UNITED STATES PATENT AND TRADEMARK OFFICE

10/849,285

Office Action Summary	Application No. 10/849,285	Applicant(s) ONO ET AL.	
	Examiner MICHAEL H. CALEY	Art Unit 2871

DETAILED ACTION

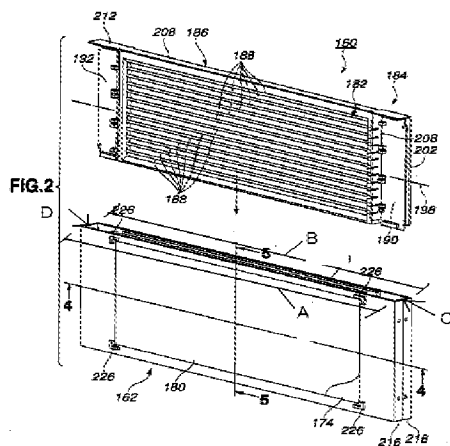
Applicant cites Specification Page 10 lines 11-20 and Figures 1, 2, 5, and 6 as providing support for the amendment. The cited portion of the specification discusses the light shield as overlapping the aperture, but does not discuss overlap with the edge of the chassis.

Figure 2 of Applicant's Drawings are reproduced below with edges labeled A, B, C, and D. Overlap between the light shield 212 and an edge portion of the aperture and chassis is clearly shown for edges A and B. For example, Figure 5 is a cutaway of Figure 6 as shown below and overlap along the edge portion is apparent (Figure 5 elements 212, 216, and 218). No

support is found, however, for overlap along the edge portion of the aperture and chassis along edges and sides C and D. Further, the edge of element 202 in Figure 2 appears to show a straight contour with element 212, such that an overlap with the chassis at edge C would not be geometrically possible.
